City of Stamford Comments on D&M Plan

CSC Docket No. 435: STAMFORD RELIABILITY CABLE PROJECT, Stamford, CT

Development and Management Plan Vol. II of III (construction activities associated with 115-kV underground transmission line)

Reviewed by Lou Casolo, City of Stamford, Engineering Bureau 10/04/2013.

Page 5-5, Sec. 5.6.1

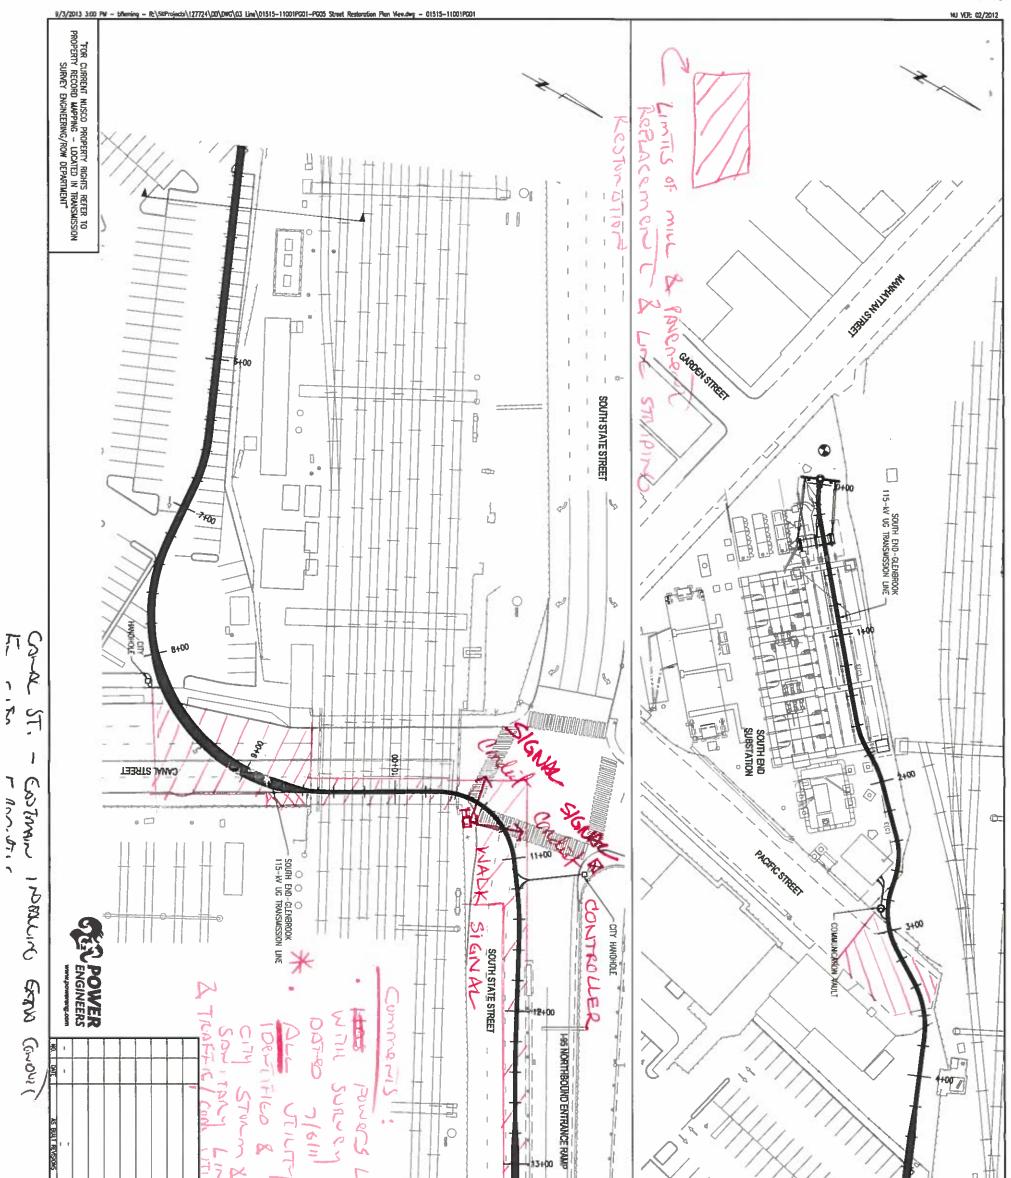
- When road closure is required, alternative traffic plans must be reviewed by C.O.S., Traffic Advisory Committee (TAC) Meeting.
- Public Outreach must be conducted to alert residents of project activities.
- Must comply with City's Noise Ordinance
- In the event that the hours of construction performed before 7am on weekdays or before 8am on weekends, Noise Permit Waiver must be obtained and approved by C.O.S. Health Department.
